Response to

Request for Additional Information No. 17 Supplement 1, Revision 0

U.S. EPR Standard Design Certification

SRP Section: 15.00.03 - Design Basis Accidents Radiological Consequence

Figure 15.00.03-24-1—Normalized Iodine Aerosol Release Airborne

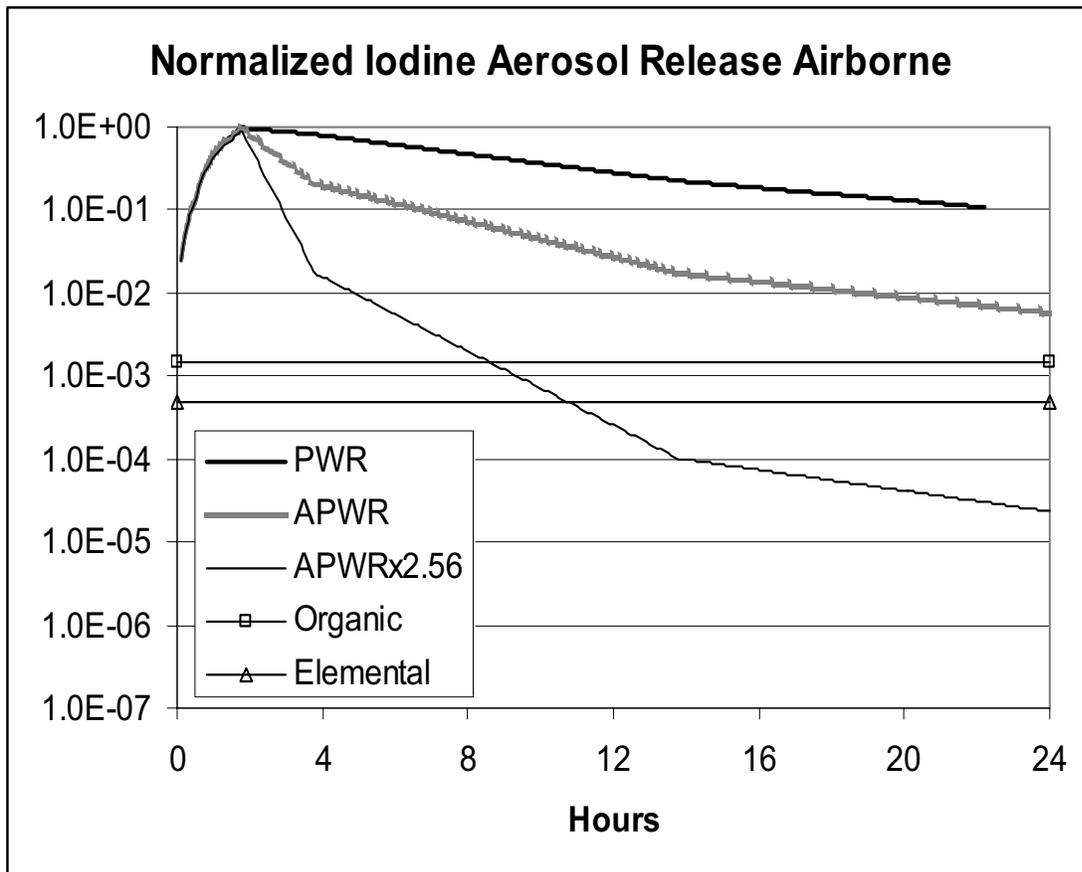
In the LOCA and REA dose analyses, the Powers natural deposition model and the “Henry model” for aerosol removal in containment were combined to model aerosol deposition in the containment. The Henry model has not previously been reviewed or found acceptable for use in reactor licensing. Please justify the use of the Henry model for aerosol natural deposition in the EPR containment.

Figure 15.00.03-24-1—Normalized Iodine Aerosol Release Airborne presents the normalized aerosol airborne activity for the U.S. EPR with and without phoretic deposition, at 4612 MWt as represented by the APWRx2.56 (4612/1800) line, based on the methodology described in Section 2.2.2.1 of NUREG/CR-6604.

The sedimentation-only rates of the 10th percentile Powers PWR correlation (as implemented in RADTRAD) are much lower than either the RADTRAD-implemented 10th percentile Powers BWR or APWR correlation values, so therefore the time frame over which the Powers PWR correlation has been defined should be much longer than 22.2 hours. The PWR sedimentation rates are conservative (if not overly conservative by virtue of having been established at the 10th percentile and the fact that they basically ignore phoretic deposition), but what substantially limits the usefulness of the correlation is the cessation of removal at 22.2 hours. It is this fundamental limitation of the Powers correlation that the time extension using the RADTRAD Henry model is intended to remedy.

Equation 1 is then used beyond 22.2 hours. Because the Henry model lambdas are a function of aerosol mass remaining airborne (ρ_A) whereas the Powers model is not, the lambdas for the Henry model decrease with time relative to the Powers 10th percentile lambdas as mass is removed. On this basis, using the Henry model to extend the Powers 10th percentile correlation beyond 22.2 hours is both reasonable and conservative. The smooth transition from the Powers to the Henry model is evident in the plot of the iodine-131 airborne activity in containment shown in Figure 15.00.03-30-1—Iodine-131 Activity Distribution in the response to Question 15.00.03-30.

Figure 15.00.03-25-1—Relationship of PWR Power to Containment Volume

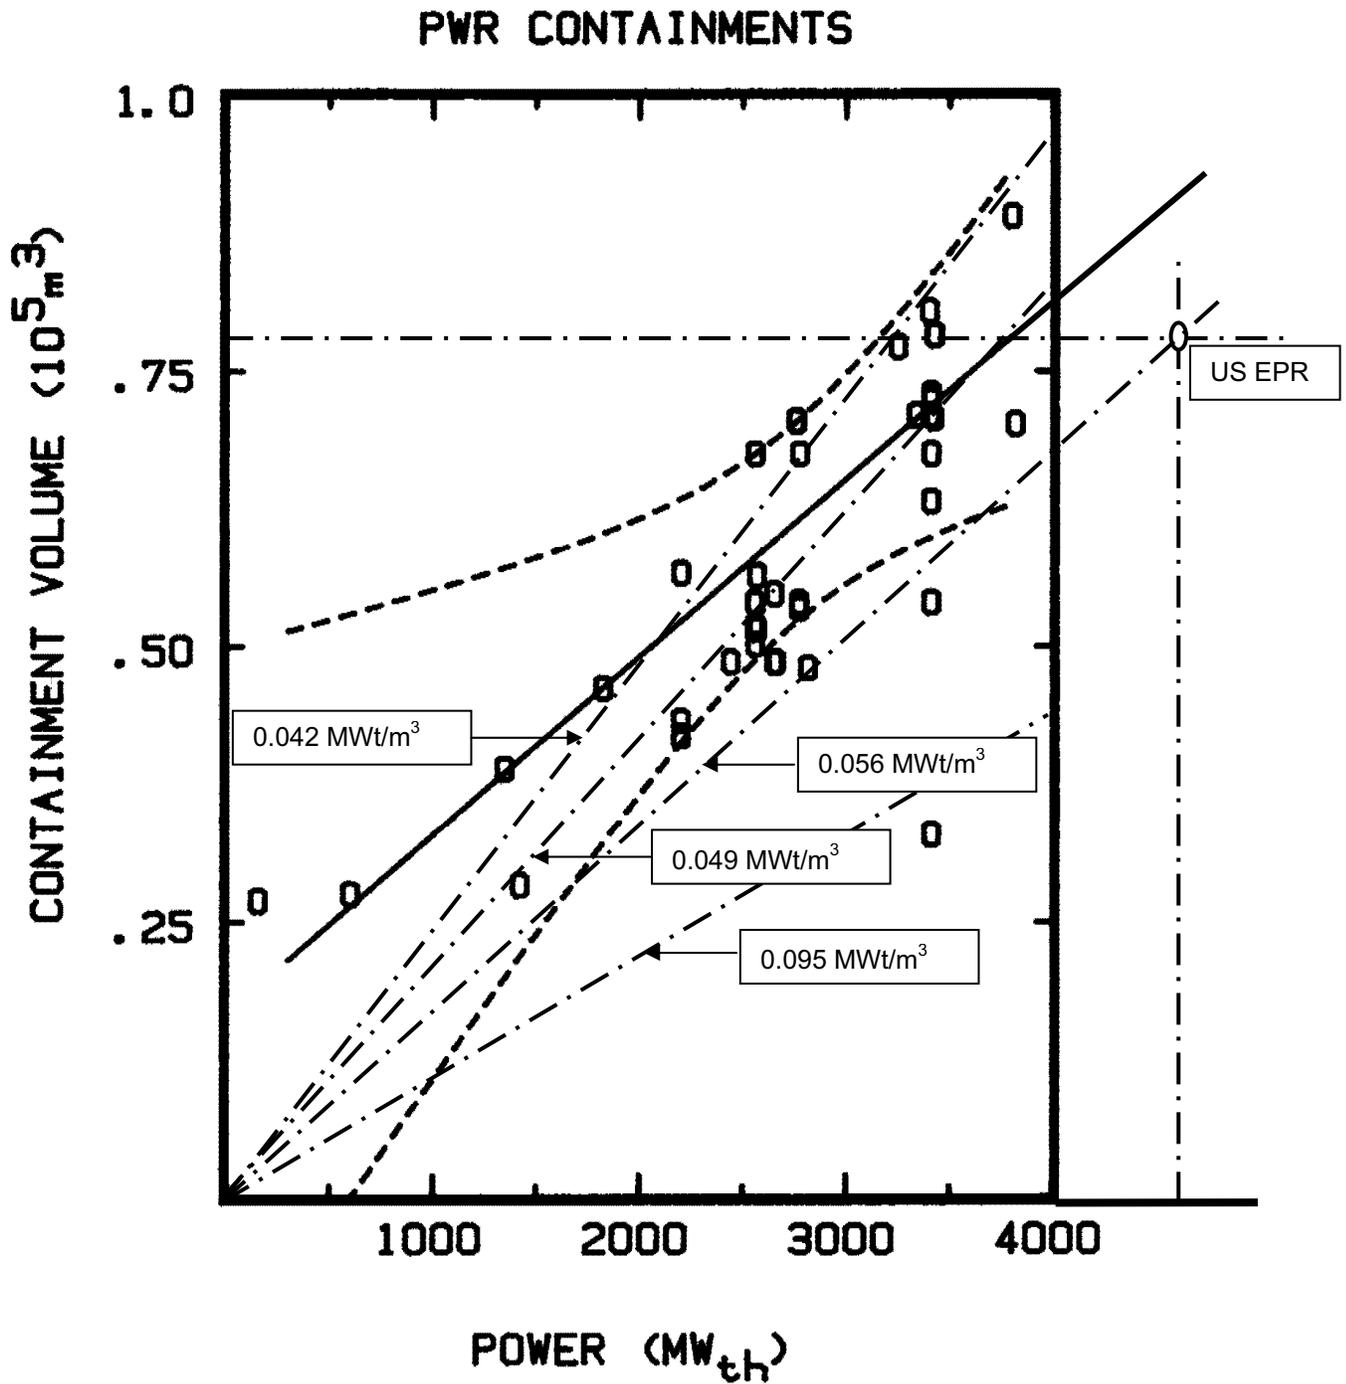
In the LOCA and REA dose analyses, aerosol deposition in containment is modeled in part by using the 10th percentile Powers natural deposition correlation in RADTRAD. Considering that the Powers natural deposition correlation was developed using operating pressurized water reactor (PWR) and boiling water reactor (BWR) information on containment geometry and power, justify the applicability of the Powers natural deposition correlation to the EPR containment.

Figure 15.00.03-25-1— Relationship of PWR Power to Containment Volume is a markup of Figure 18 in NUREG/CR-6189, “A Simplified Model of Aerosol Removal by Natural Processes in Reactor Containments,” the supporting document for the Powers natural removal correlations found in NUREG/CR-6604, “RADTRAD: A Simplified Model for RADionuclide Transport and Removal And Dose Estimation.”

The original NUREG/CR-6189 Figure 18 shows the data considered in establishing the functional relationship between containment volume and the reactor power level. Figure 18 considers reactor power as high as 4000 MWt. The solid line is the correlation line for the 32 data points considered. It has the formula $V(m^3) = 16700(\pm 5500) + 16.16(\pm 1.94) \bullet P(MWt)$, where V is the volume and P is the power level, and has been extended beyond 4000 MWt to include the power level of the U.S. EPR.

The actual volume of the U.S. EPR containment ($7.9E4 m^3$) is within the stated uncertainty ($1.4E4 m^3$) when compared to the central estimate of the volume according to the formula ($9.1E4 m^3$). It is near the favorable limit of the uncertainty; i.e., the smaller the containment volume, the higher the mass concentration and the greater the sedimentation rate. The volume of the U.S. EPR is near the most favorable (smallest) end of range of PWR containment volumes (per unit reactor power) considered statistically possible with respect to the development of the Powers correlations. Even the median sedimentation rate based on a statistical treatment of the reactor power/containment volume relationship described by the formula above is conservative for the U.S. EPR.

Figure 15.00.03-25-1 shows plots of the three NUREG-1150 reactor power per unit containment volume values and the value for the U.S. EPR. For small power levels there are significant deviations; however, at reactor power levels above 1000 MWt, three of the four plotted slopes describe the range of the data reasonably well with Zion providing the upper bound of containment volume for a given reactor power level, Surry providing the central estimate, and the U.S. EPR providing the lower bound. The statistical outlier is Sequoyah, which is understandable given its ice condenser containment design.

Figure 15.00.03-30-2—Fractional Core Release Rate for Iodine to IRWST

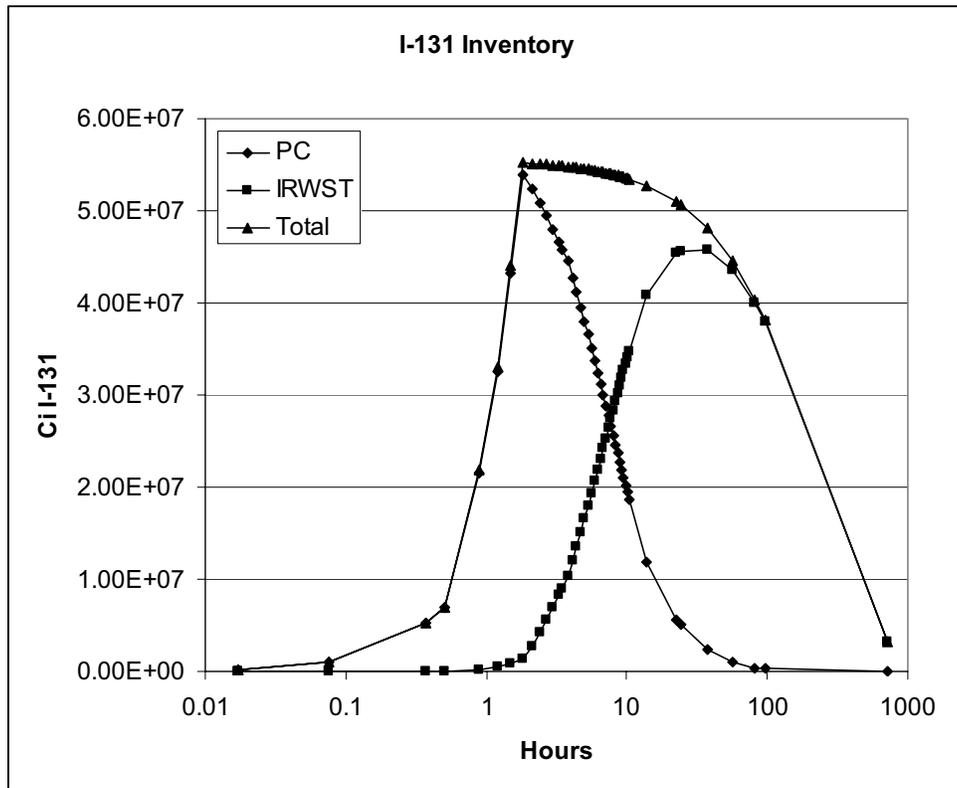
In regard to the LOCA engineered safeguard features (ESF) component leakage dose analysis, provide the ESF component leakage source term and the basis for the assumed values.

The fractional iodine release rates from the core directly to the IRWST that will mimic removal from the primary containment atmosphere (due to natural deposition) are shown in Figure 15.00.03-30-2—Fractional Core Release Rate for Iodine to IRWST and tabulated in Table 15.00.03-30-1.

The area under the curve in Figure 15.00.03-30-2 is 0.4, representing 40 percent of the total iodine release. As presented in Figure 15.00.03-30-2, most of the iodine enters the IRWST from 1.5 to ten hours. These rates assume that decay in the core is accounted for separately.
